November 2017  
FL741A  
NHTSA #17V-451  
REVISED NOTICE

## **Subject: FCCC XCR Chassis Battery Cables**

**Models Affected: Specific Freightliner Custom Chassis  
XCR chassis manufactured November 27, 2012, through  
February 23, 2016.**

**Fig. 1, Battery Cable Bracket, Correct Installation**

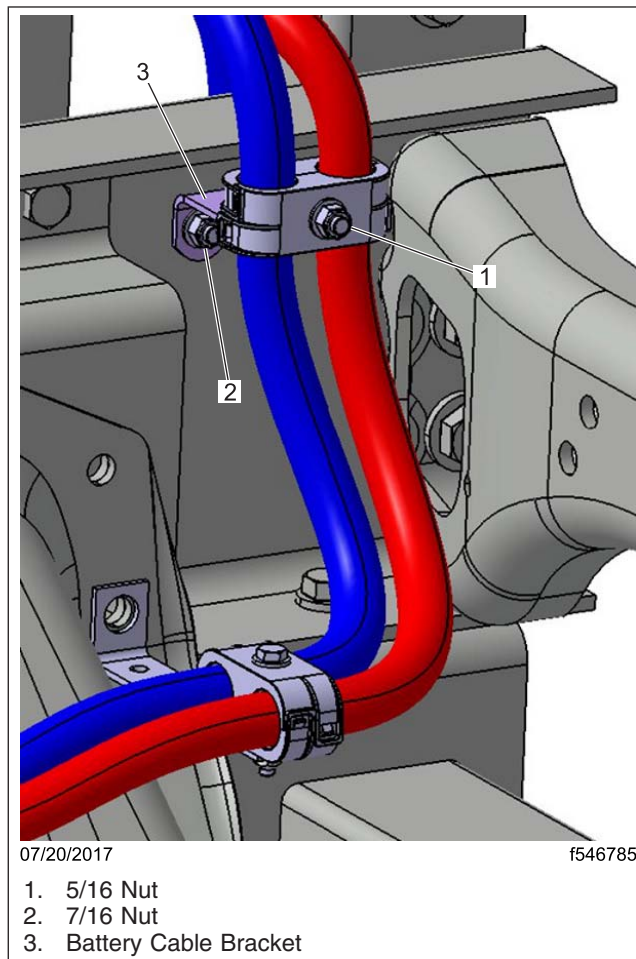
On certain vehicles a battery cable mounting bracket may have been incorrectly installed causing the battery cable to be improperly routed. If improperly routed, the battery cable may come in close proximity to the frame rail and cause rubbing or shorting of the cable. A potential battery cable short between the cable and the frame rail may increase the risk of a fire.

1. Check the base label (Form WAR259) for a completion sticker for FL741 (Form WAR260) indicating this work has been done. The base label is usually located on the front wall under the dash. If a sticker is present, no work is needed. If there is no sticker, proceed with the next step.
2. Park the vehicle on a level surface, shut down the engine, and set the parking brake. Chock the tires.
3. Inspect the battery cable bracket for correct orientation. The bracket should be installed on the frame rail so that the battery cables do not rub the frame rail or any other components. See [Fig. 1](#).
  - If the battery cable bracket is correctly installed, no further work is required. Clean a spot on the base label (Form WAR259). Write the recall number, FL741, on a completion sticker (Form WAR260), and attach it to the base label to indicate this recall has been completed.

1. Remove the 5/16 nut and washer from the portion of the bracket holding the battery cables and set the nut and washer aside.
2. Loosen the 7/16 nut that attaches the battery cable bracket to the frame rail and correctly rotate the bracket as shown in [Fig. 1](#).
3. If the battery cable bracket is missing, install it on the frame rail using the 7/16 nut and washer assembly. See [Fig. 1](#) for proper installation.

4. Tighten the 7/16 nut and washer assembly 42 lbf·ft (57 N·m).

**Fig. 2, Battery Cables Rubbing the Frame Rail**

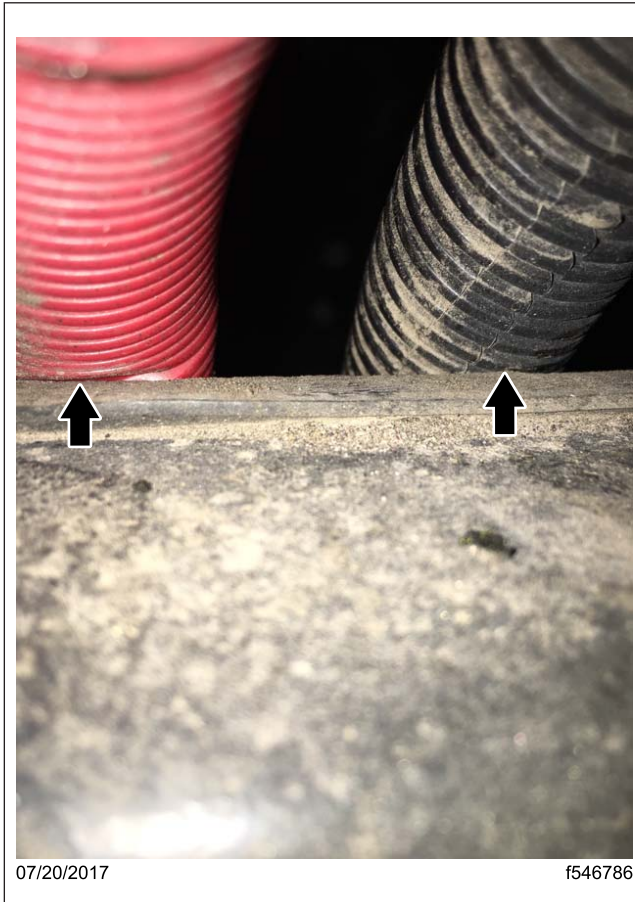
- If the battery cable bracket is incorrectly installed or missing, inspect the battery cables for damage. It is possible for the conduit that covers the cable to be damaged, but the battery cables are not damaged. Damage to the battery cables could include, but is not limited to, a cut in the battery cable or visible cable insulation. See [Fig. 2](#) and [Fig. 3](#). After inspection of the battery cable, go to 'Battery Cable Bracket Procedure.'

**IMPORTANT:** If the battery cable(s) are damaged, replace the battery cable(s). It is possible for the conduit that covers the cable to be damaged, but the battery cables are not damaged. Damage to the battery cables could include, but is not limited to, a cut in the battery cable or visible cable insulation. See [Fig. 2](#) and [Fig. 3](#)
